Subject: September 21, 2007 Preliminary Flood Insurance Rate Map
Comments from the City and County of San Francisco

City and County of San Francisco
Summary of Requested Changes to the September 21, 2007
Preliminary Flood Insurance Rate Map (FIRM)

Comments on FEMA Preliminary Flood Insurance Rate Map

Re: Mission Bay North of Channel
FEMA Mapping Zone A Boundary

CATELLUS		OWNER	PROJECT MANAGER	FOOTLAB, LLC	CATELLUS URBAN
471 MONTGOMERY ST. SUITE 600 SAN FRANCISCO, CA 94104 TEL: 415.398.1100 FAX: 415.398.1101		REVISIONS			
MISSION BAY PROJECT - SAN FRANCISCO, CA		NORTH OF CHANNEL 2007 FEMA FLOOD CONTROL BOUNDARY			
1"=20'		0334007007			
SHEET 1 OF 4

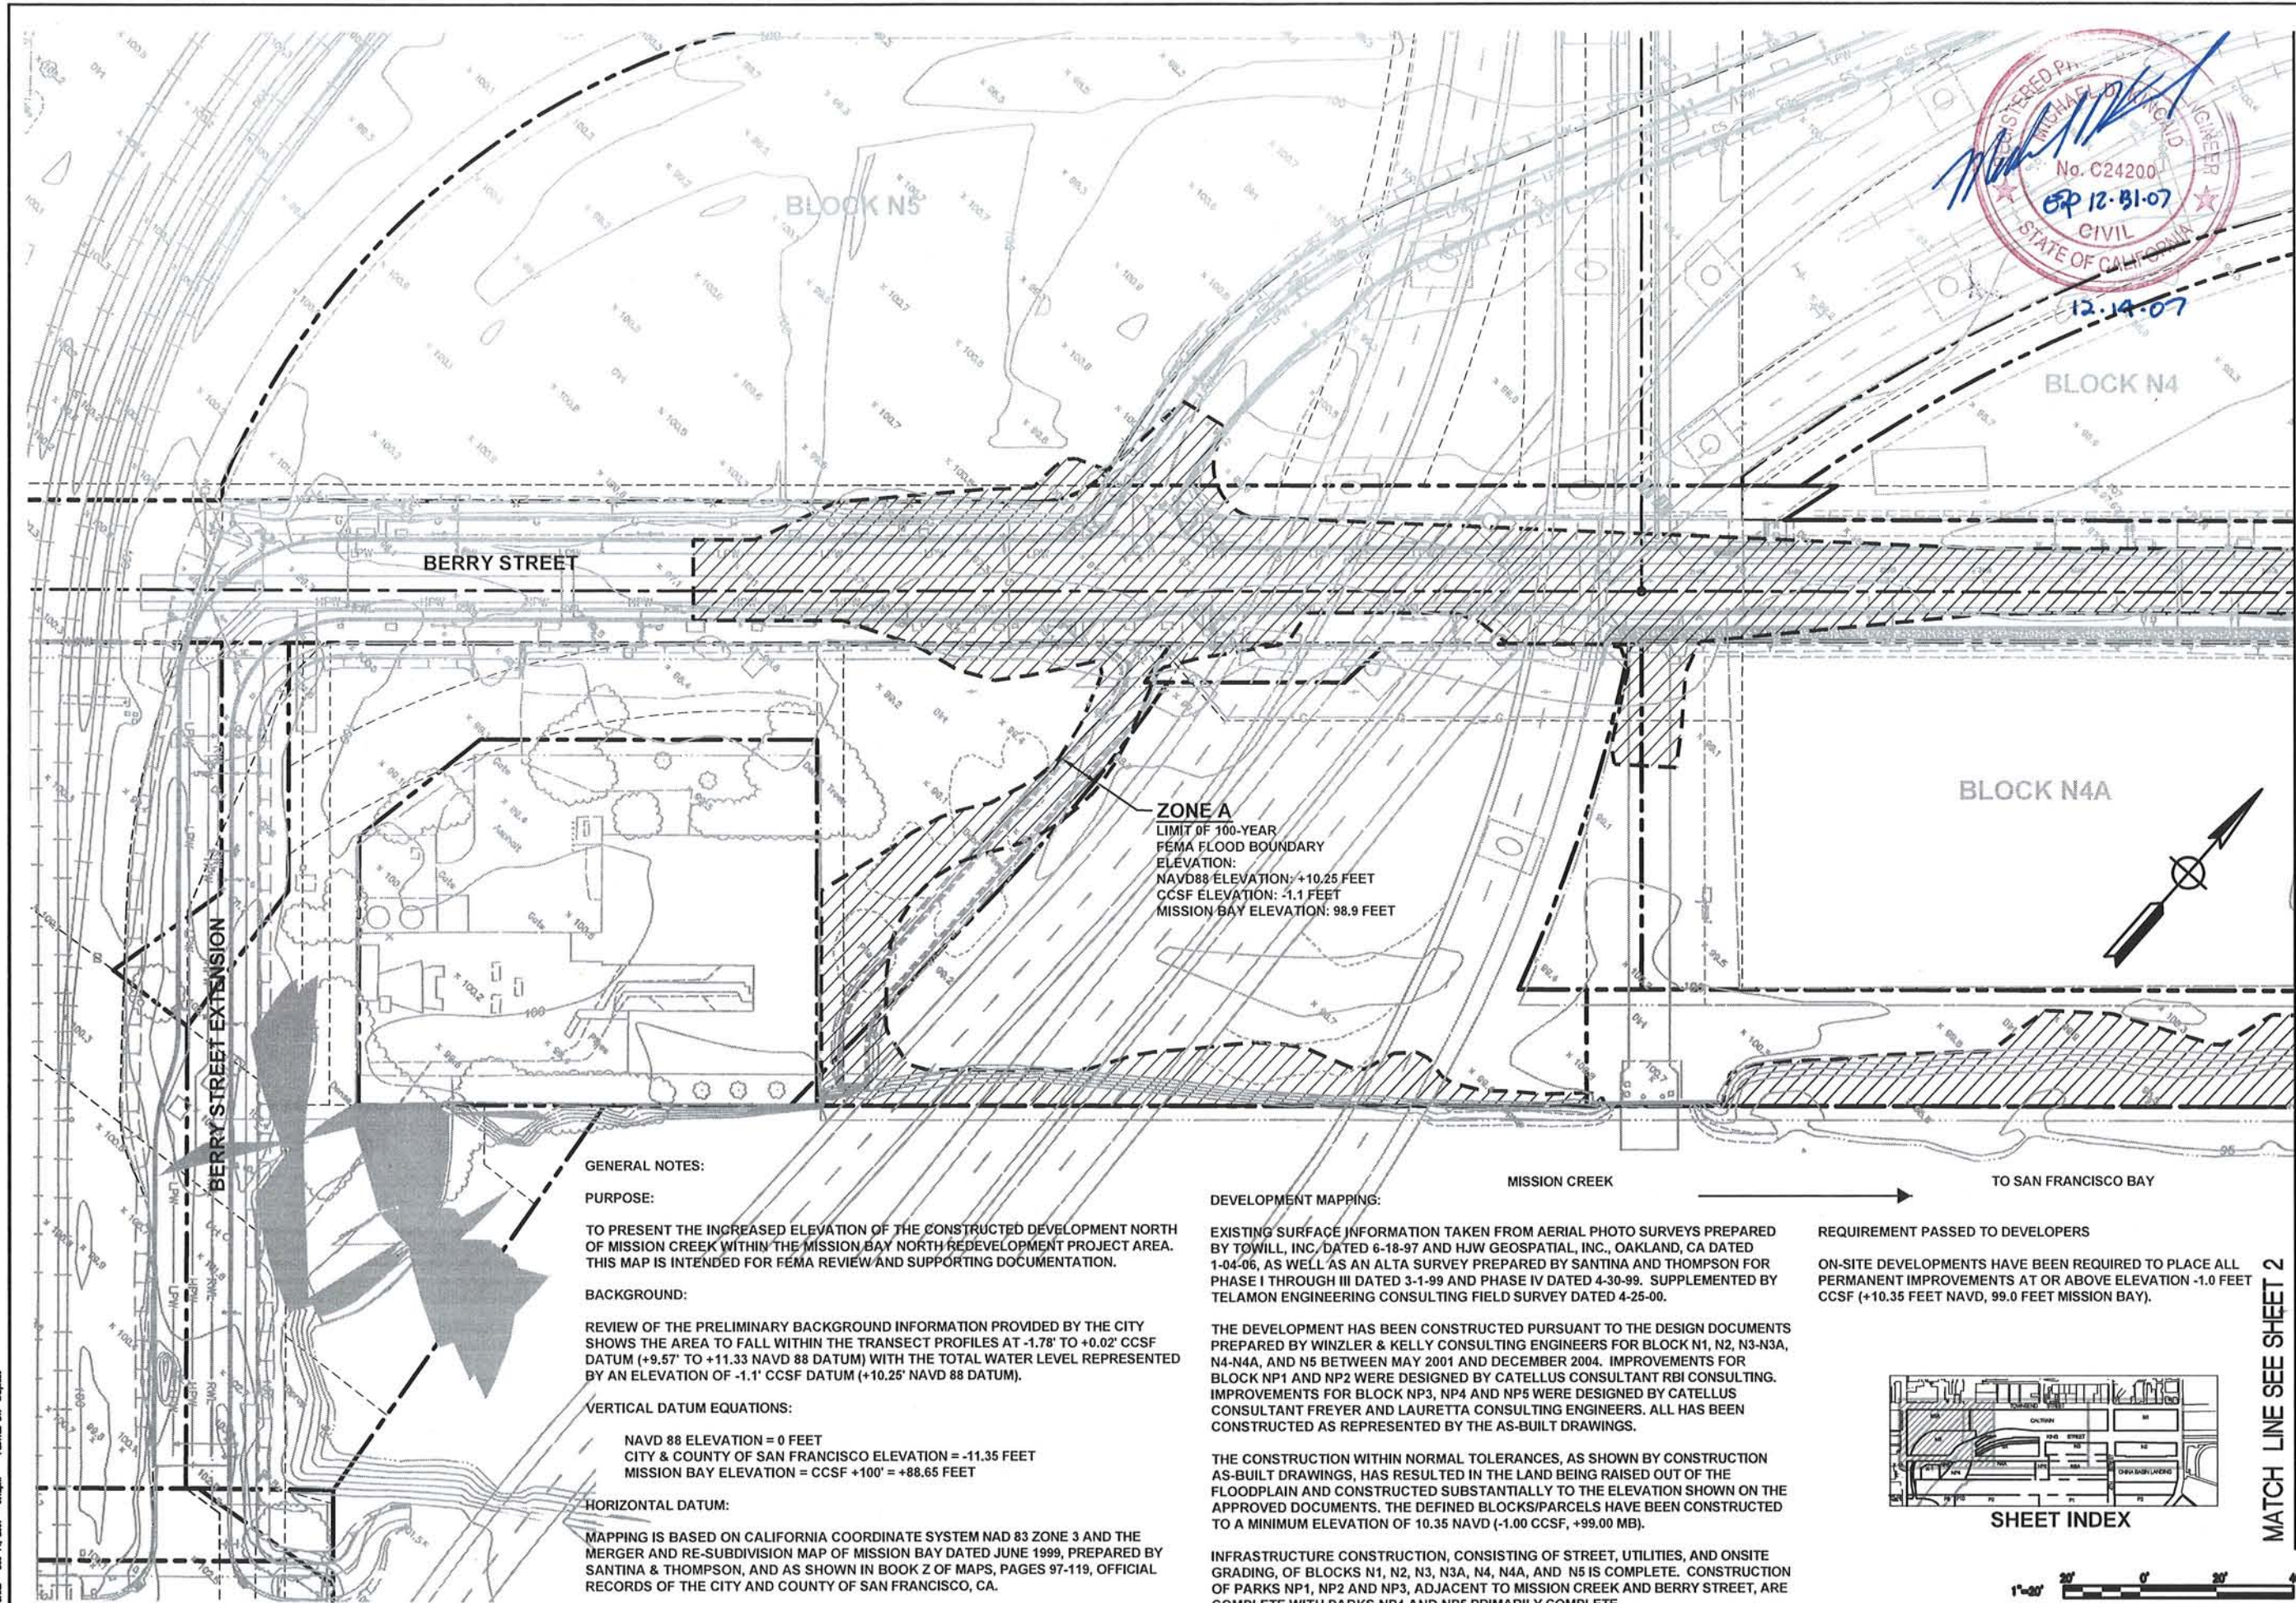
Sheet 1 of 4 – NORTH OF CHANNEL 2007, FEMA FLOOD CONTROL BOUNDARY
Indicates topography and the limit of the Zone A 100-Year FEMA Flood Boundary. The plan includes Block N4 and N4A and a Portion of Block N5, along with the intersection of Berry Street and Berry Street Extension.

ZONE A
LIMIT OF 100-YEAR
FEMA FLOOD BOUNDARY
ELEVATION:
NAVD88 ELEVATION: +10.25 FEET
CCSF ELEVATION: -1.1 FEET
MISSION BAY ELEVATION: 98.9 FEET

SHEET 2 of 4

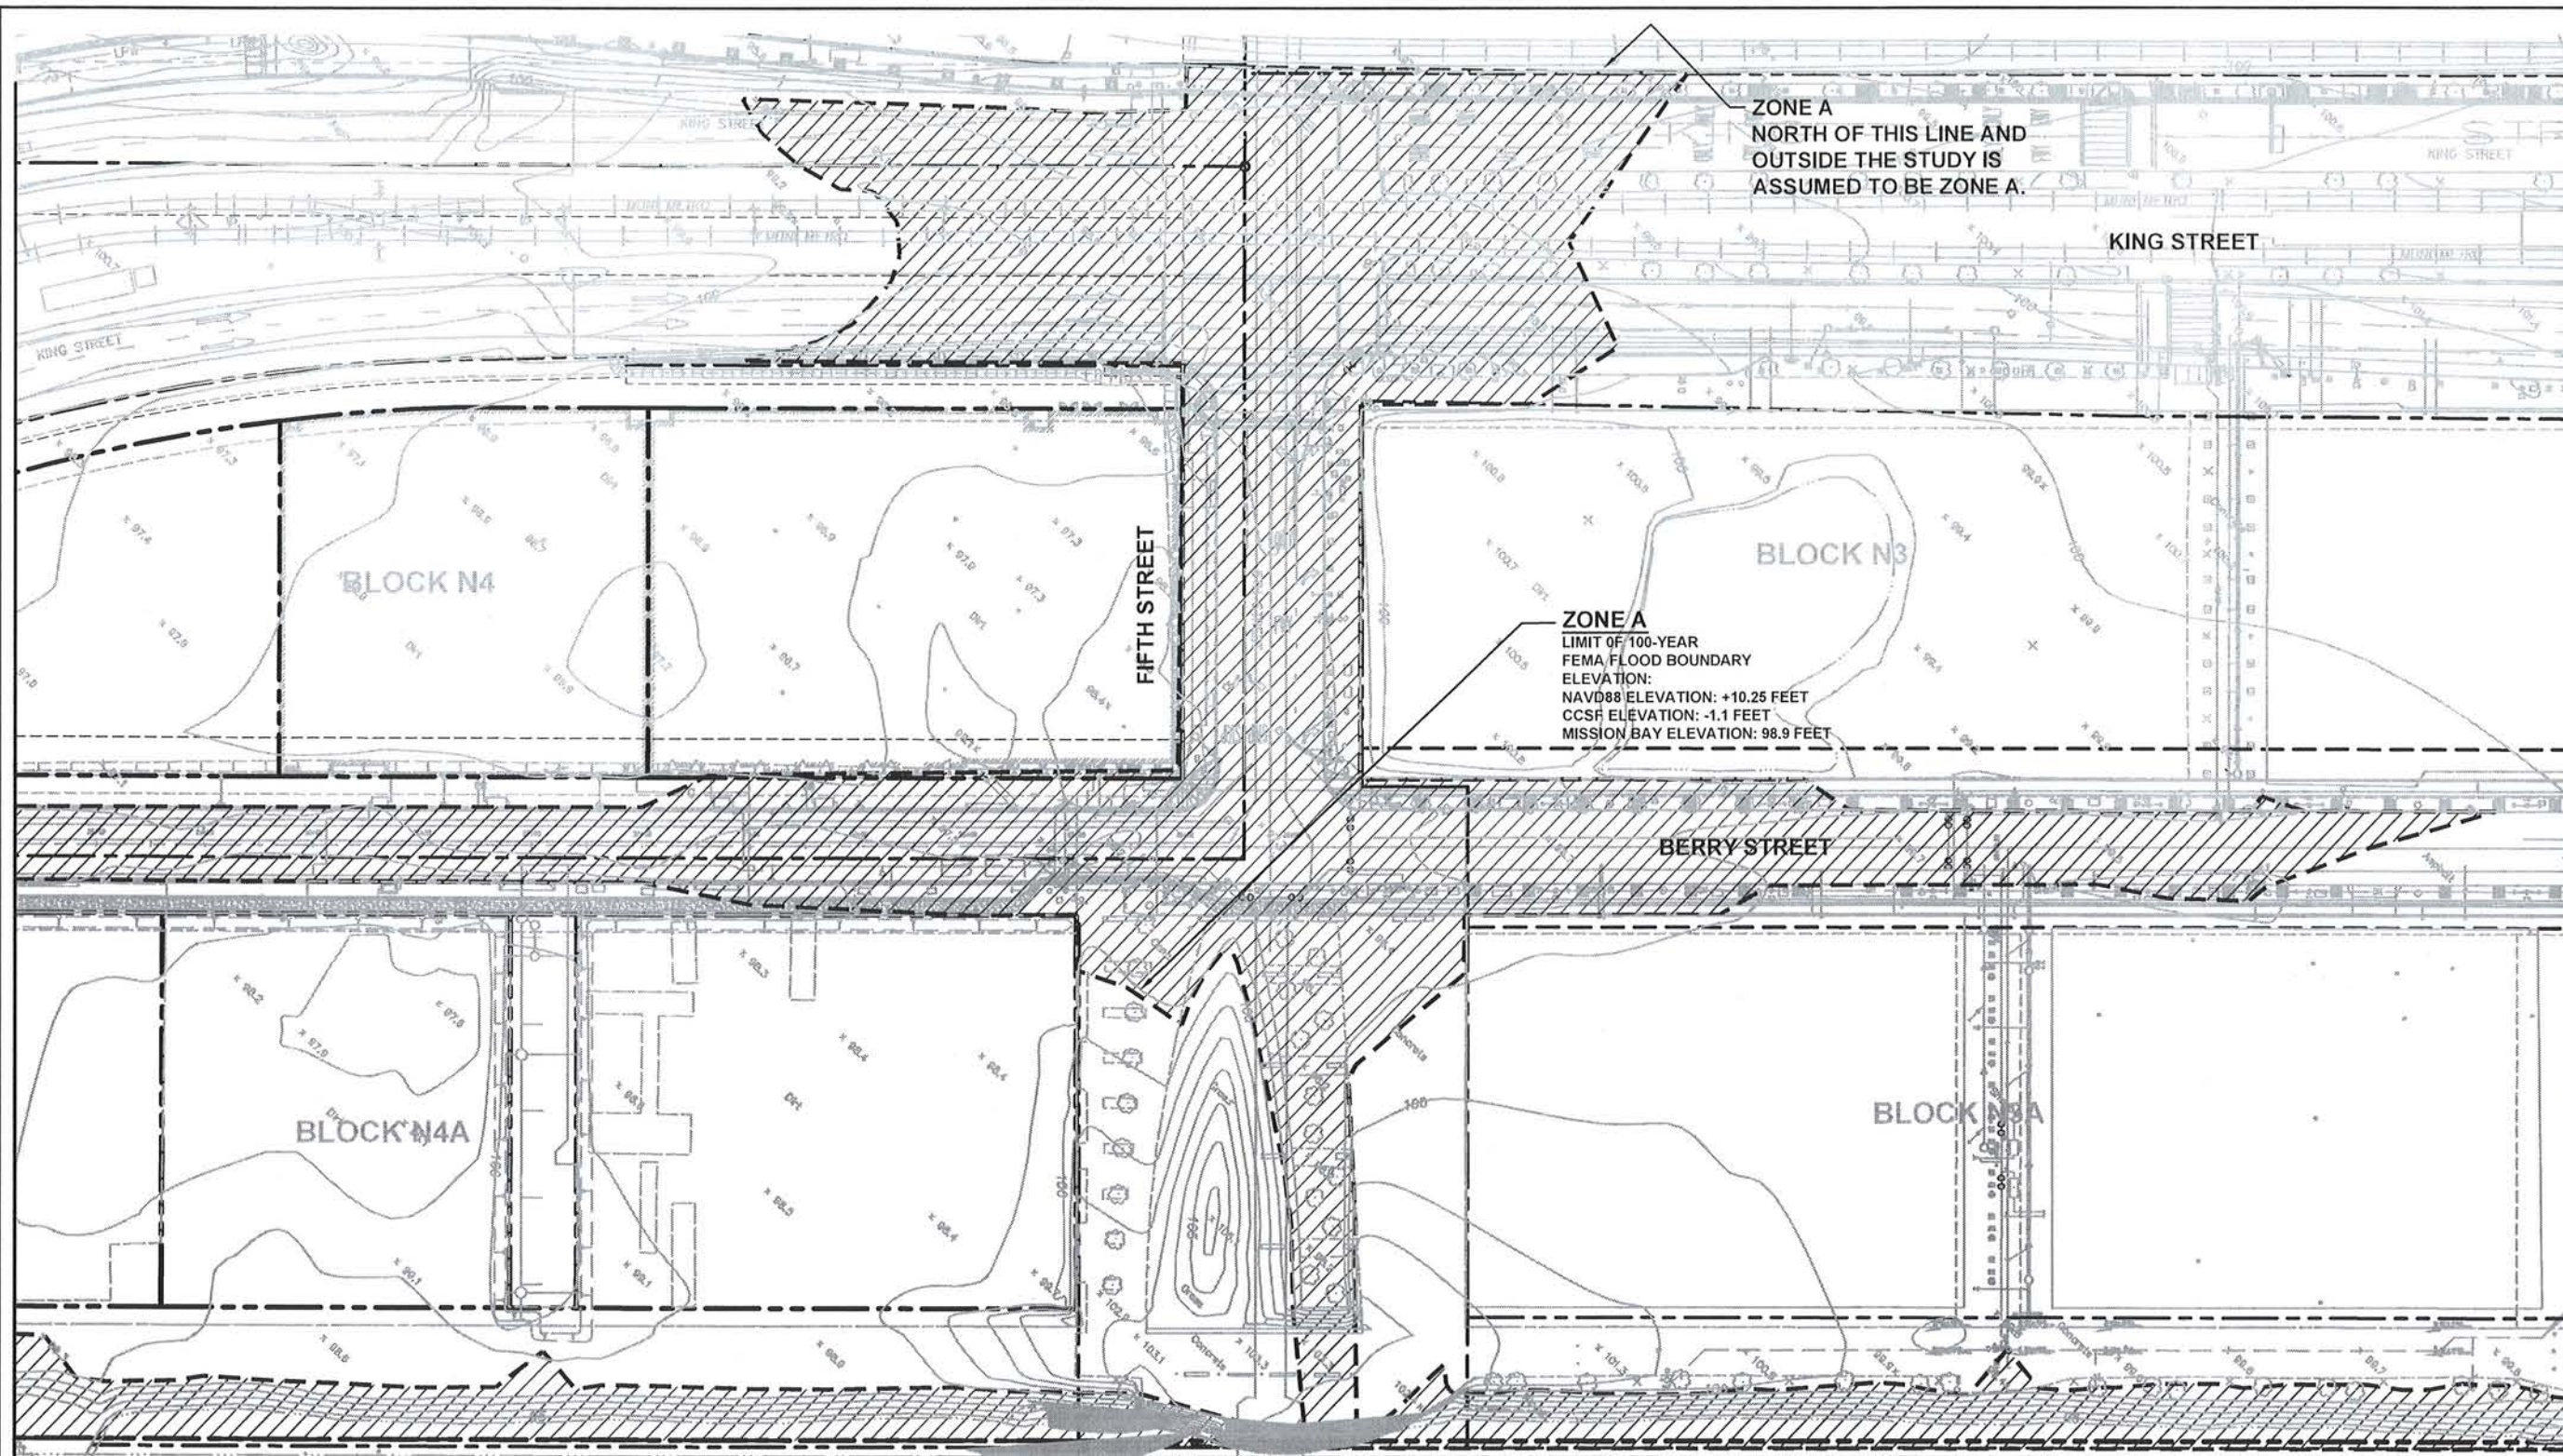
Sheet 2 of 4 – NORTH OF CHANNEL 2007, FEMA FLOOD CONTROL BOUNDARY
Indicates topography and the limit of the Zone A 100-Year FEMA Flood Boundary. The plan includes a portion of Block N3, N3A, N4 and N4A along with the intersection of Fifth Street and King Street.

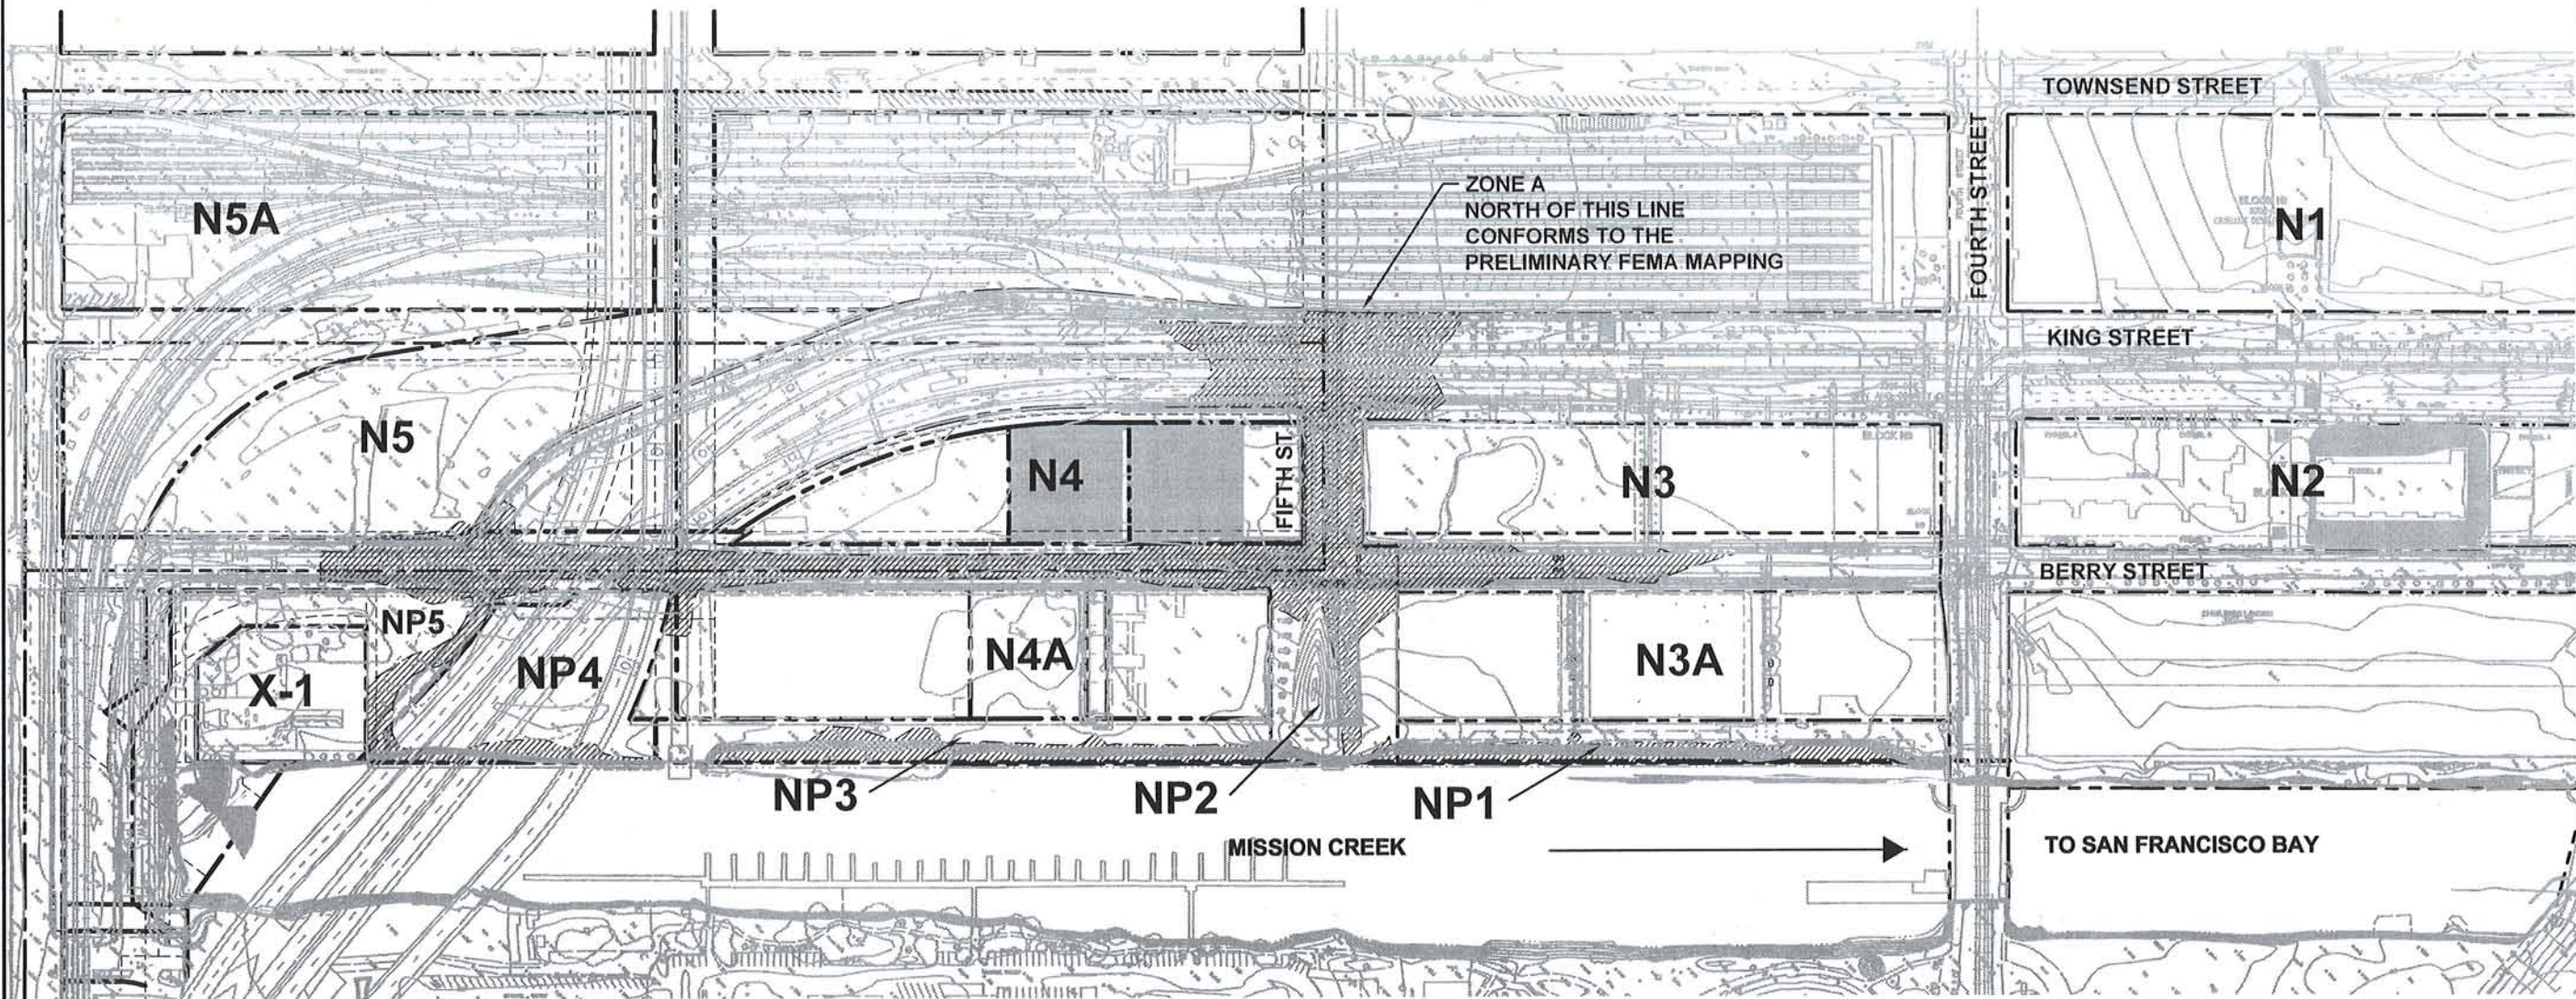
Sheet 4 of 4 – NORTH OF CHANNEL 2007, FEMA FLOOD CONTROL BOUNDARY
Indicates the topography and the limit of the Zone A 100-Year FEMA Flood Boundary and all areas in question from Sheets 1 through 3 above on an overall map.
